Reply to Referee #1 on “Sensitivity of simulated CO<sub>2</sub> concentration to regridding of global fossil fuel CO<sub>2</sub> emissions”

Reply to Referee #2 on “Sensitivity of simulated CO<sub>2</sub> concentration to regridding of global fossil fuel CO<sub>2</sub> emissions”

Reply to Dr. David Calvin on “Sensitivity of simulated CO<sub>2</sub> concentration to regridding of global fossil fuel CO<sub>2</sub> emissions”

**Fig. 5.** Regional fluxes difference and simulated annual mean surface  $\text{CO}_2$  concentration differences (experiment minus control) and the location of TAP monitoring site. a) flux difference; b) concentration difference. Blue stars mark the location of TAP site.

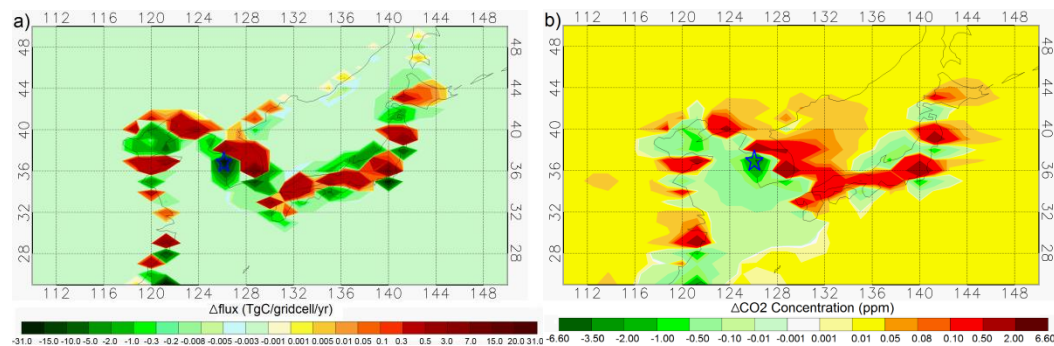
Second (and related): Although the paper focuses on the global scale, the problem at hand plays at the regional/local scale, as illustrated in figure 1. However, the findings at station TAP are treated in a rather hand-waving way, glossing over the remarkable fact that the simulated mixing ratios in the “experiment” simulation are lower than in the control, while in general the opposite would be expected (for land stations at least, since the emissions are transferred to land locations). A more local focus of figures 2 and 3 would therefore be of large value for this paper, e.g. highlighting the specific situation around station TAP.

P 3584, line 17: Concerning the TAP station. “The TAP monitoring station is located in the negative portion of the emission dipole displayed in Fig. 3”. This would imply that the TAP station is allocated to an ocean/lake grid cell? I think it would improve the paper further if a figure (maybe use figure1?) is added to outline the specific case for TAP (where is the station? How are the emissions from large cities shuffled? How do the detailed CO<sub>2</sub> concentration fields differ?) From the global lot (figure 3) it is hard to discern the TAP location in the “emission - difference” dipole.

We agree that highlighting the location of station TAP in emission and concentration fields could clearly present the significant effect of “shuffling the fluxes from ocean grid to land grid” on this station. We have added an additional figure (Fig. 5) to show the phenomenon in the manuscript. We also added additional explanation of Fig. 5 in the text: “The TAP monitoring station is

located in the negative portion of the emission dipole (emission difference:  $-24.1 \text{ TgC/gridcell/yr}$ ) corresponding to the positive emission portion on adjacent land gridcells, as displayed in Fig. 5a. Consistently, the TAP site lies in the negative portion of the annual mean surface  $\text{CO}_2$  concentration field ( $-6.60 \text{ ppm}$ ) opposing to the positive portion on land (Fig. 5b).”

Thanks for the suggestion. We agree that an additional figure that highlights the location of station TAP in emission and concentration fields could be helpful in showing the significant effect of “shuffling the fluxes from ocean grid to land grid” on this station. We have added an additional figure (Fig. 5) for this purpose.

We also added additional explanation of Fig. 5 in the text: “The TAP monitoring station is located in the negative portion of the emission dipole (emission difference: -24.1 TgC/gridcell/yr) corresponding to positive emission portion on adjacent land gridcells, as displayed in Fig. 5a.

Consistently, the TAP site situates in the negative portion of the annual mean surface CO<sub>2</sub> concentration field (-6.60 ppm) opposing to the positive portion on land (Fig. 5b).”
